The Montefiore Home, Randwick

BCA Section J1 & J2 Deemed-to-Satisfy Review of Fabric & Glazing Requirements

Prepared for
Jackson Teece

2.5.1 Glazing requirements summary

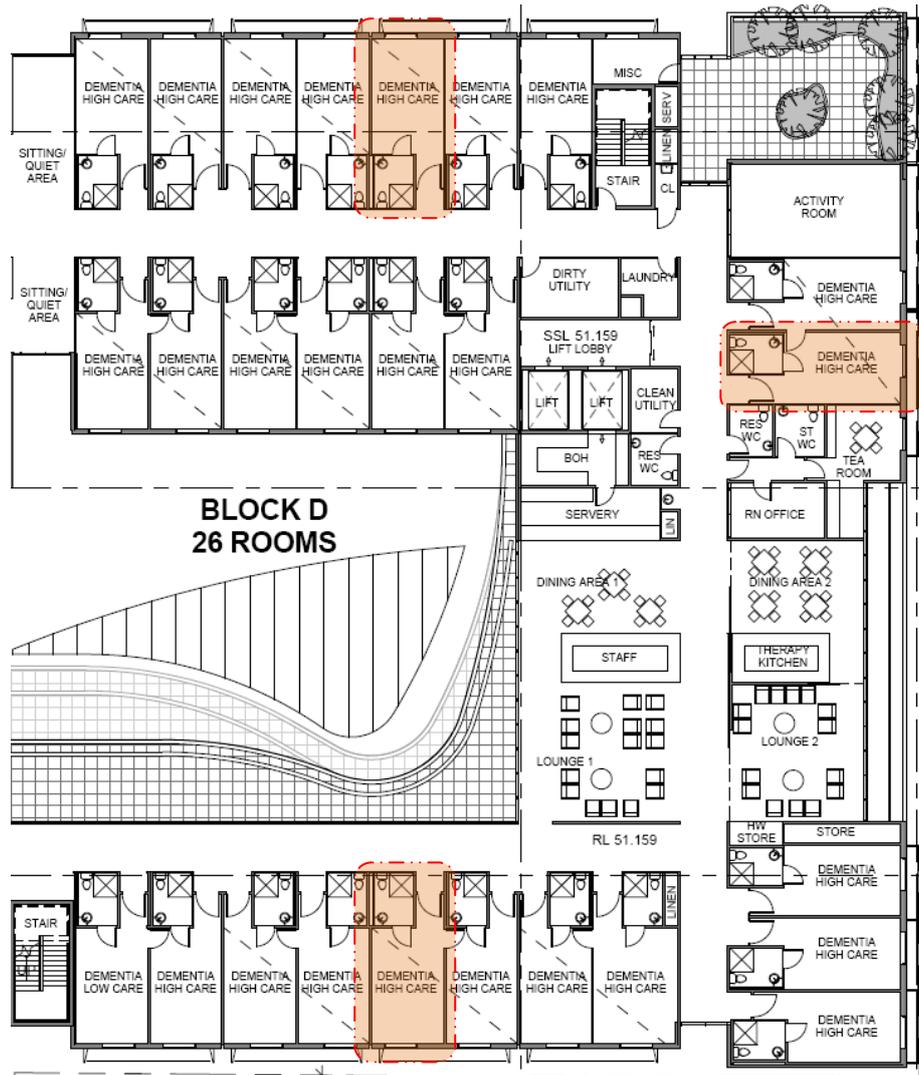
All buildings will pass deemed-to-satisfy provisions with the current shading treatment assuming the following mentioned glazing performance figures:

Shading is as per detailed on architectural plans and elevations on a typical storey:

Note: West facade typical window configuration is assumed to be identical to East Facade of Block D.

Facade Orientation	Location	U-value	SHGC
N	Stage 2 Block C,D	5.8	0.81
S	Stage 2 Block C,D	5.8	0.81
E	Stage 2 Block C,D	5.8	0.81
W	Stage 2 Block C,D	5.8	0.81

Note: Shading is as per architectural plans. Glazing performance characteristics are glass values only.
